[Docket No. 2003-SW-38-AD]

#### **Airworthiness Directives; Eurocopter Deutschland Model MBB-BK 117 A-1, A-3, A-4, B-1, B-2, and C-1**

**ACTION:** Notice of proposed rulemaking (NPRM).

Vertical Fin-Skin Panelling  
Figure 1

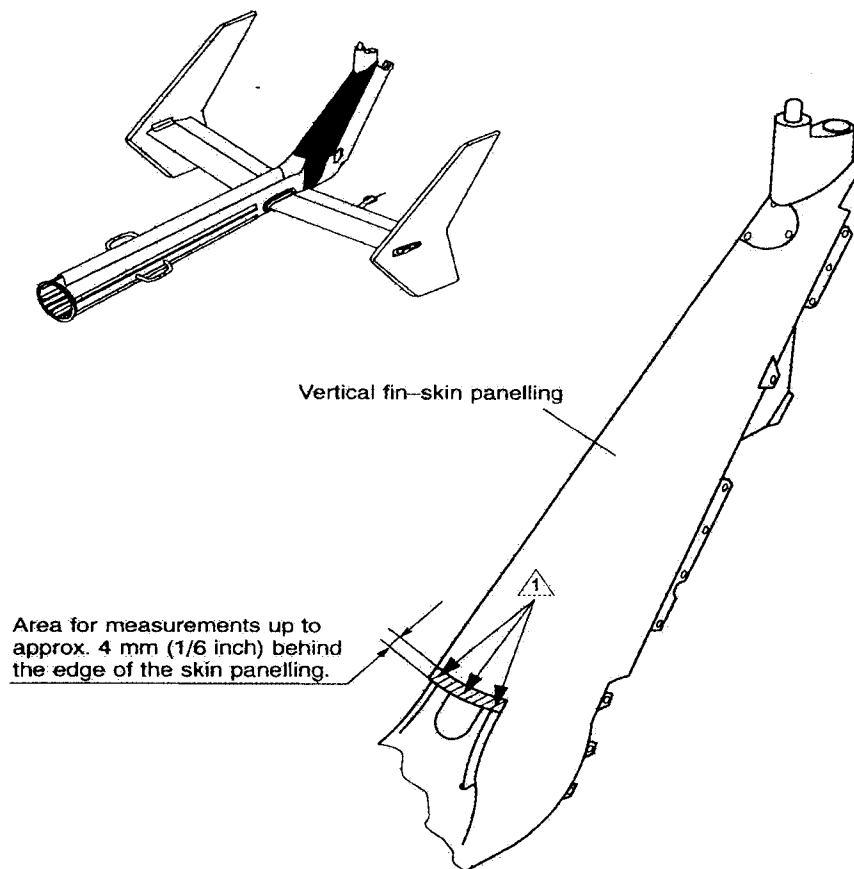
(a) Using external calipers, measure the wall thickness, including primer coating, of the skin paneling of the vertical fin at the locations shown in Figure 1 of this AD.

- △ 1 Measurements are to be taken at at least three locations on the skin panel of the vertical fin. Care has to be taken that the external calipers are held squarely to the skin panel wall while measurements are being taken, since tilting of the calipers can lead to false results. If the panel thickness, including the primer coating, is at least 0.778 mm (0.03063 inch) at every measured location, no further action is necessary.

(b) If the wall thickness, including the primer coating, of the panelling is less than 0.778 millimeter (0.03063 inch) at any of the measured locations, replace the vertical fin with an airworthy part before further flight.
